TITLE: **555 West Middlefield Road Residential
Development Project**

PURPOSE

The purpose of this Study Session is for the City Council to provide input on a proposed 348-unit addition (including an on-site 1.48-acre public park) to an existing 402-unit apartment complex located at 555 West Middlefield Road.

Figure 5 – Street Facade and Corner Massing, Lot 1

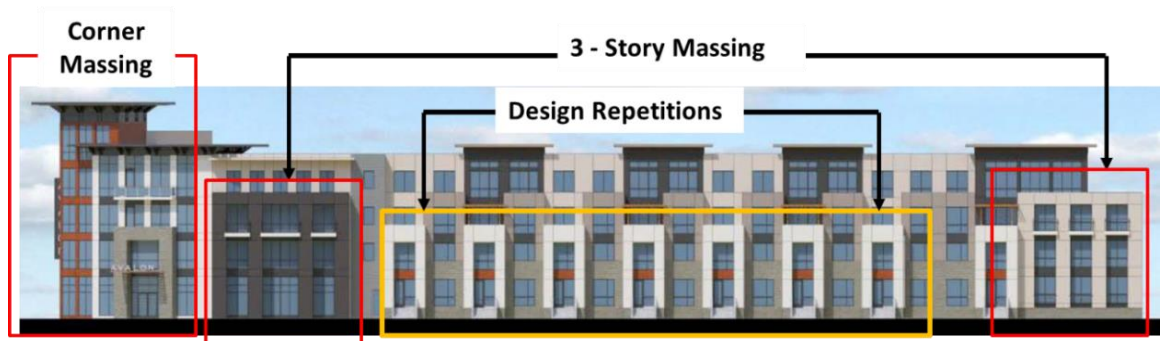
The R4 design guidelines provide direction to maintain appropriate scale and pattern of development that is compatible with existing neighborhoods. As shown below, the proposed four-story building includes two- and three-story elements closer to the street. However, taller elements need better pedestrian-scaled features, and the proposed materials (currently ledgerstone and fiber cement panels) should provide a warmer, residential character.

Staff will continue to work with the applicant on features that promote integration with the surrounding lower-density residential area and adjacent on-site buildings, including: porches, entries, and bay features to establish a strong relationship with street frontages and to emphasize more pedestrian-scale elements; upper floor step backs and other design elements to deemphasize taller massing; variation and breaks in long facades; and color/material palettes to provide a more current/updated residential character while better integrating with the lower-density area surrounding the project site.
